**RB397, RB217**

BULLETIN NO.

RB397-MK1

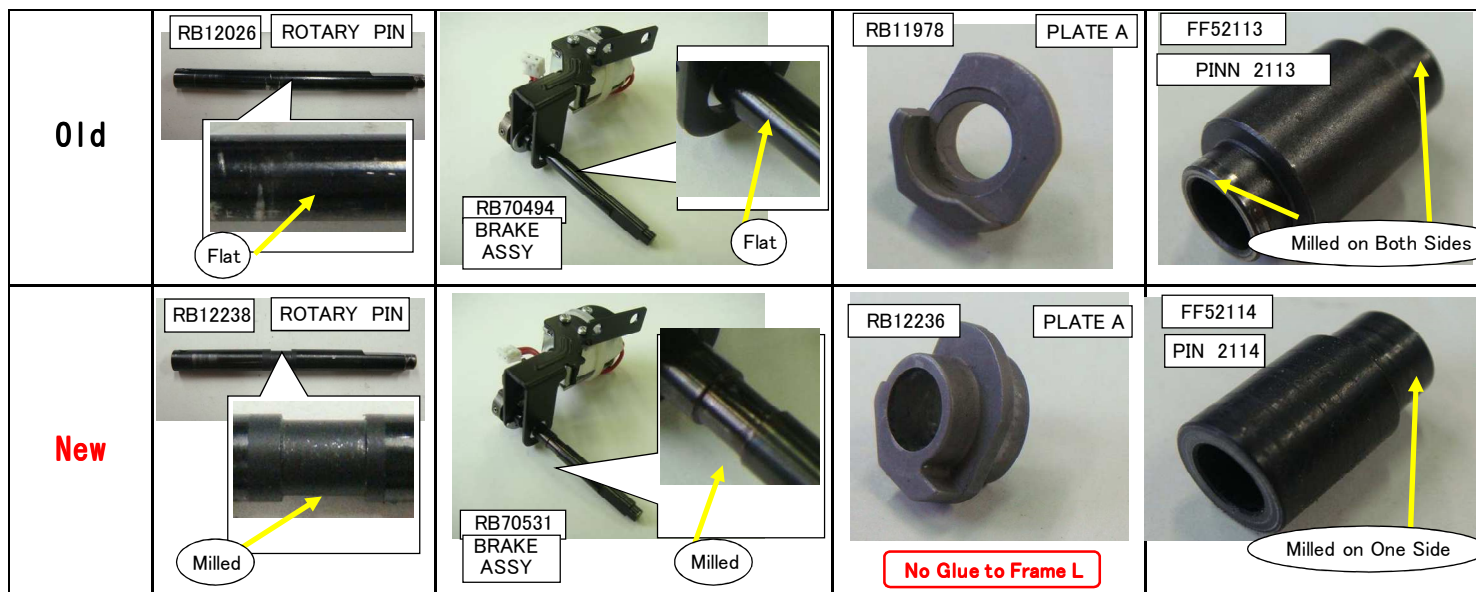
In order to improve stability of brake parts for RB397 and RB217, three parts were changed (Rotary Pin, Plate A, Pin 2113). Also, Rotary Pin in the Brake Assembly was changed to new version.

If you change one of 3 parts to new version, please change the rest of 2 parts to new version, too. Old Plate A (RB11978) was glued to the Frame L, but please **DON'T GLUE** new Plate A(RB12236) to the Frame L. \*These parts are already used for RB397 and RB217.
